Service Bulletin No. SB-AG-21

09-21-88

METAL FIN SPAR REINFORCEMENT

FIGURE A

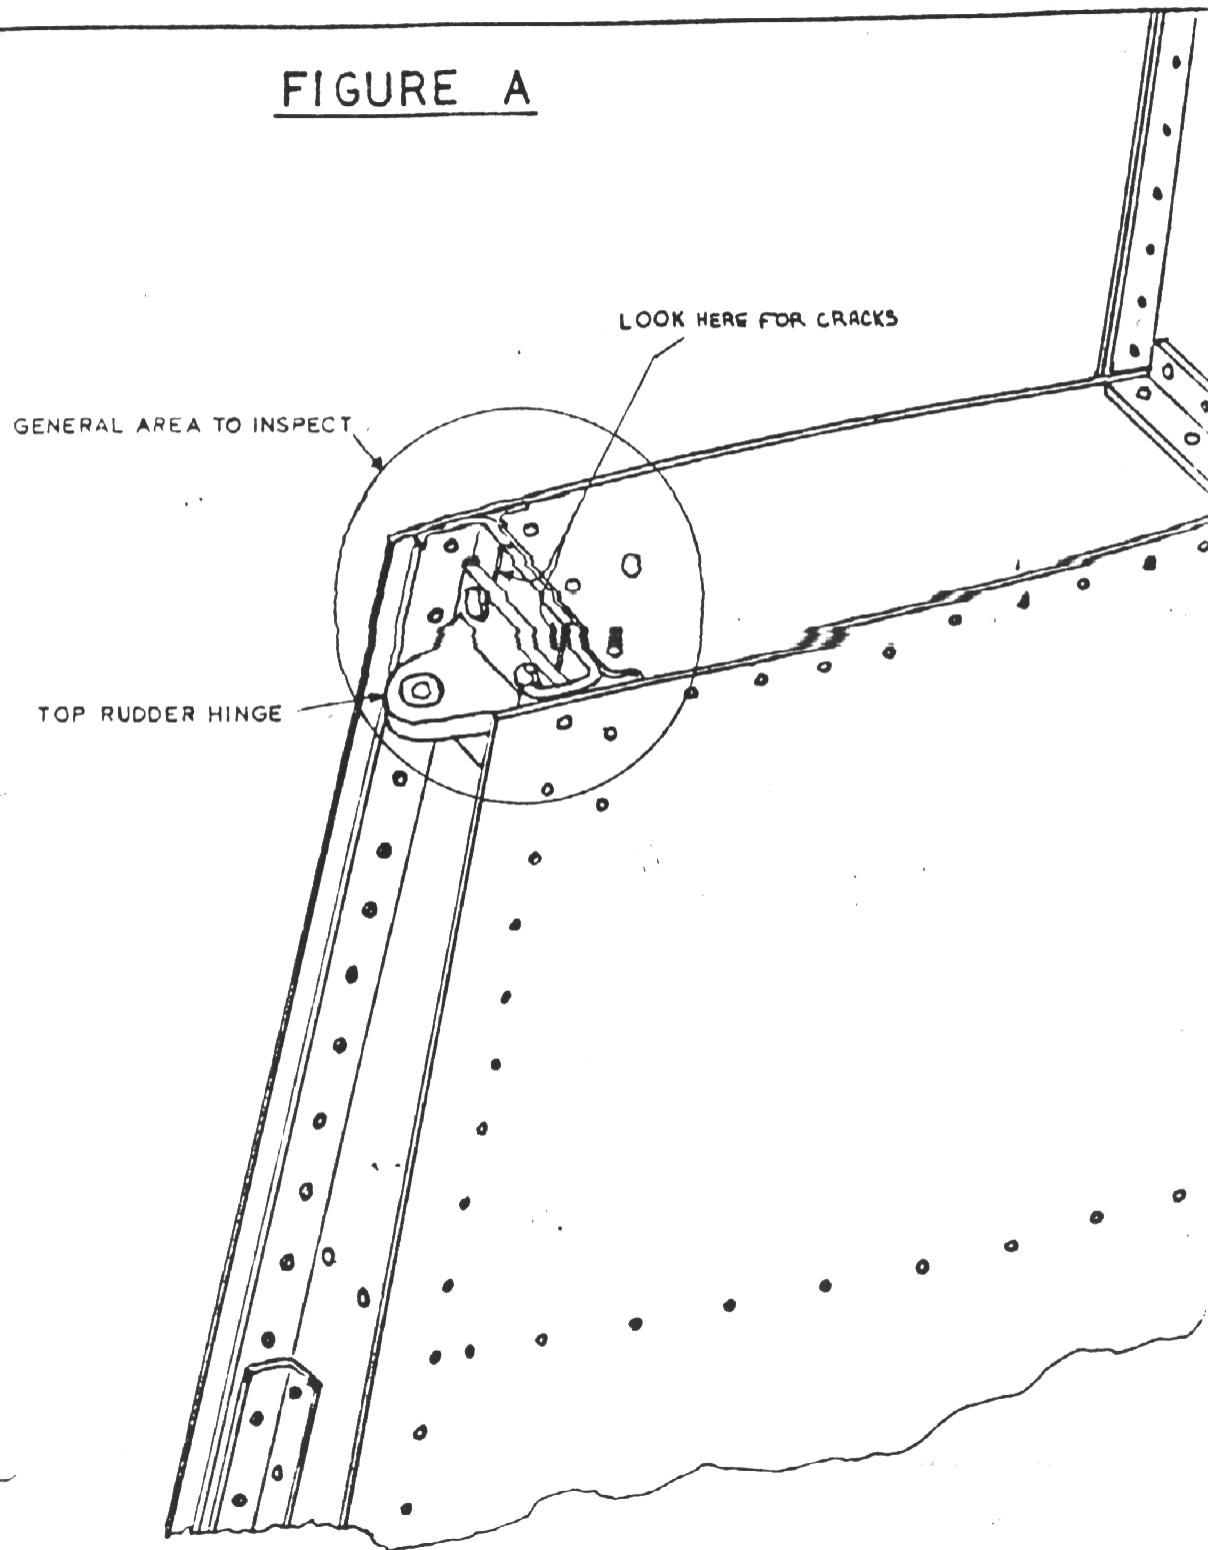
REASON FOR PUBLICATION: TO PREVENT THE POSSIBILITY OF FATIGUE CRACKS FORMING IN THE TOP OF THE FIN REAR SPAR IN THE AREA JUST ABOVE THE UPPER RUDDER HINGE BRACKET.

COMPLIANCE: WITHIN THE NEXT 50 HOURS OF FLIGHT PROVIDED THE AREA IN QUESTION IS INSPECTED PRIOR TO EACH FLIGHT. THIS PREFLIGHT INSPECTION MUST BE CONTINUED UNTIL SB-AG-21 IS ACCOMPLISHED. SEE FIGURE "A" FOR AN ILLUSTRATION OF THE AREA TO BE INSPECTED. IF ANY CRACKS ARE FOUND, ACCOMPLISH THIS SERVICE BULLETIN PRIOR TO NEXT FLIGHT.

FIGURE B

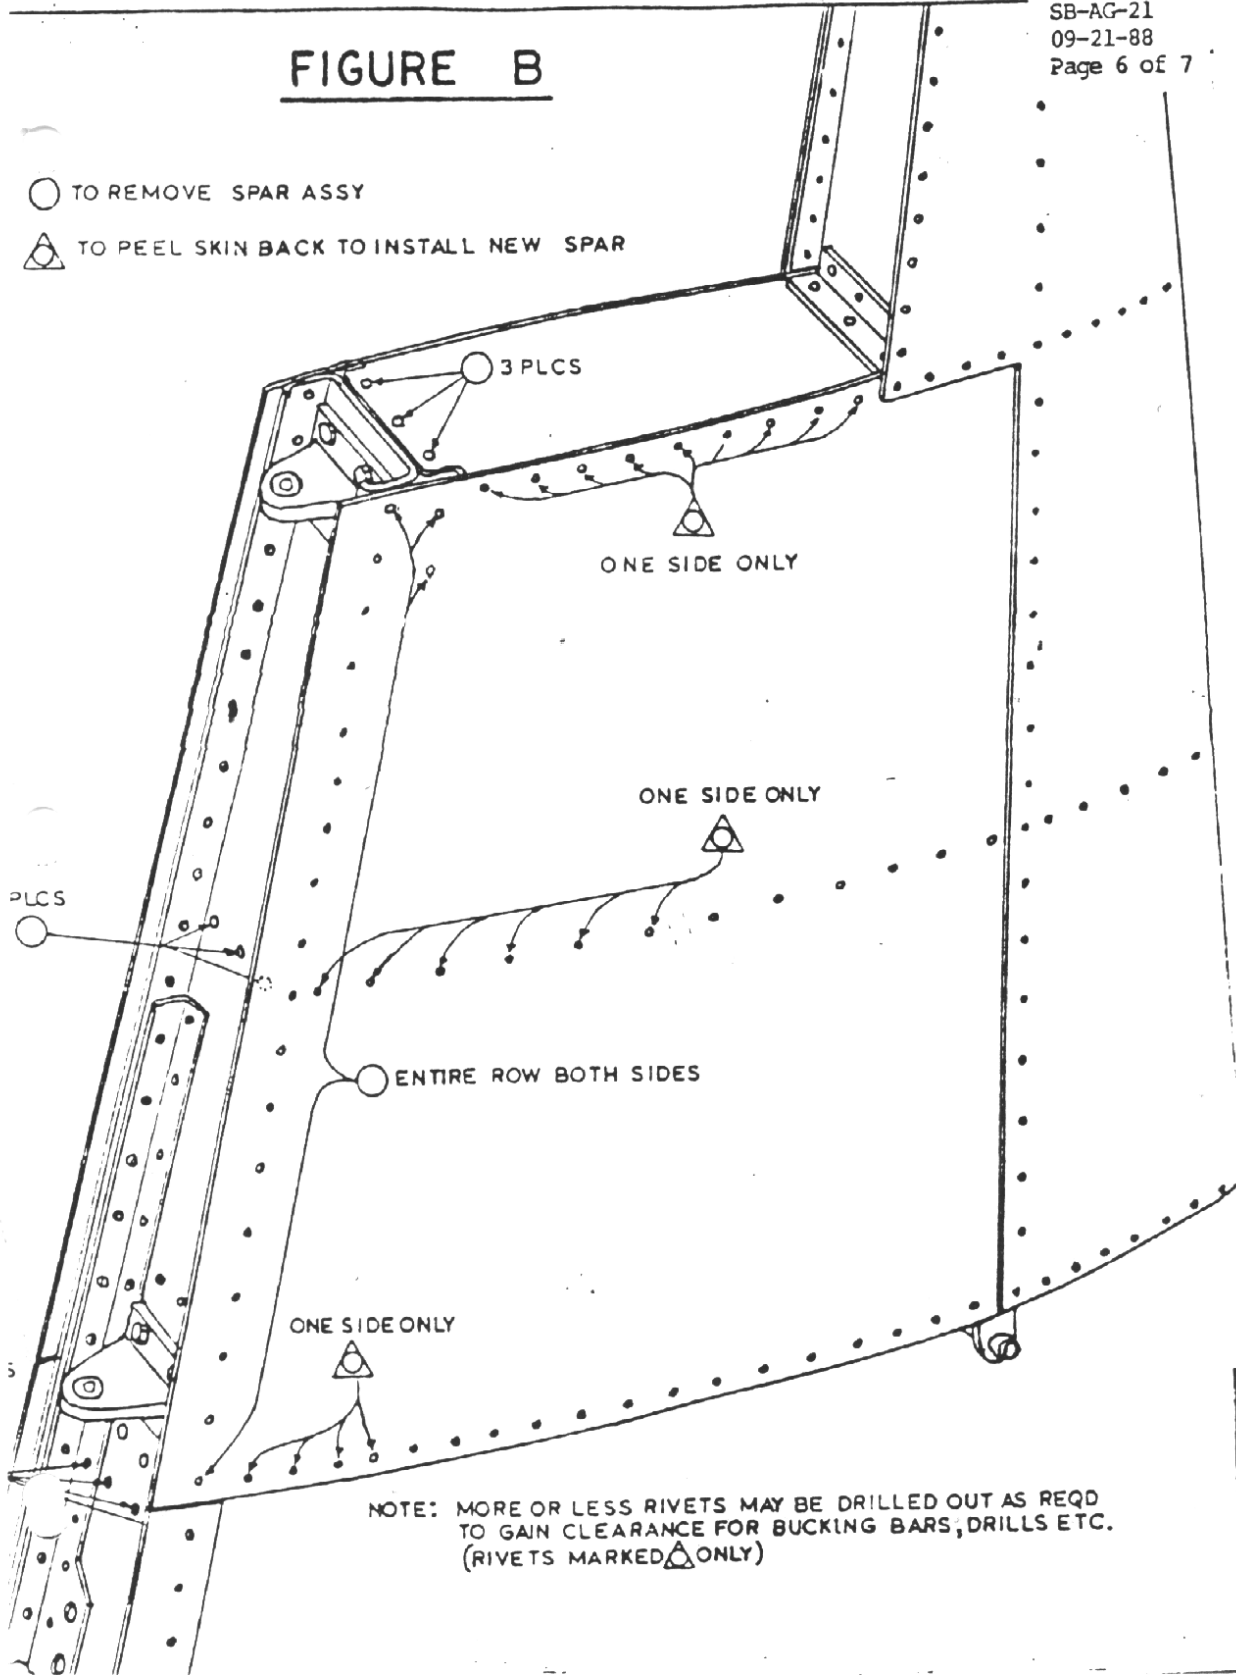
- Remove the rudder from the aircraft.
- Remove the vertical fin from the aircraft.
- Drill out all of the rivets that attach the rear spar of the vertical fin to the remaining structure. (These rivets are marked 0 in Figure "B".) (All rivets are 1/8 inch diameter.)

- Remove the rear spar from the fin.
- In addition, on one side of the fin only, drill out the rivets marked in Figure B. This will allow the skin on one side only to be peeled back. (All rivets are 1/8 inch diameter.)
